TEMPORARY ORDINANCE NO. 4-20

AN ORDINANCE AMENDING THE ZONING MAP FOR THE 18.939 ACRE PROPERTY BETWEEN NORTH MEMORIAL DRIVE AND NORTH COLUMBUS STREET/NELSON ROAD PARCEL NUMBERS 0532152400, 0532152600, 0532144900, 0532145000

**CHANGE OF ZONING REQUEST
Flats on Memorial
City Planning Commission Meeting
February 13, 2020**

CASE No.: 2020.003

SHEET 6

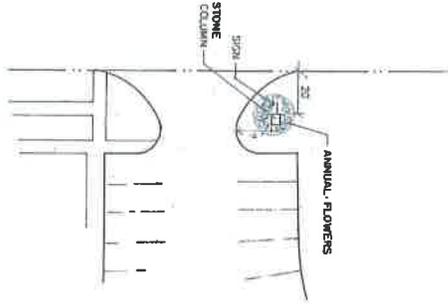
4. Per LCO 1147.04(b)(2), signs for PUD properties must comply with the provisions of Chapter 1317. The Development Plan has proposed the construction of two off-premises signs, but Chapter 1317 does not allow the construction of off-premises signs.

The staff has no recommendation. If Planning Commission recommends any form of approval of the Development Plan with any signage within the public-right-of-way, then staff recommends that the recommendation for approval be given contingent upon the developer signing a standard Affidavit of Understanding for locating signs within the public right-of-way.
